# Product Change Notification (PCN)

PCN Number	500819	Date Issued	May 24, 2016
Product Family	Please refer to the full part list attachment for details.		
Series	Please refer to the full part list attachment for details.		
Reason for Change	Capacity change or tool replacement		
Change Type Description	This letter is to inform you that another set of tooling is being added to meet the current and future demands of this product. There will be no changes in the fit, form or function from the additional tooling when compared to the current tooling. See pictures below for more information.		
Reason for Short Notice	New Capacity		
Assessment of Change	Product will be fully qualified before it is shipped. Qualification reports are available upon request.		
Internal Molex Qualification Date	July 05, 2016		
Sample Availability Date (Changed Part)	July 05, 2016		
Planned Implementation Date	July 05, 2016		
Method of Identifying Change	Product made after planned implementation date can contain the change

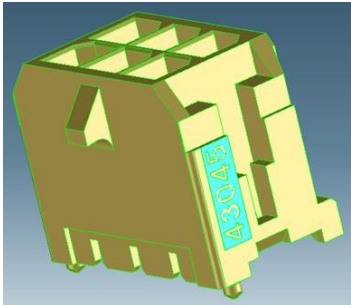
Before Change

Housing from the current mold

After Change

Housing from the new mold with no fit, form or function changes.
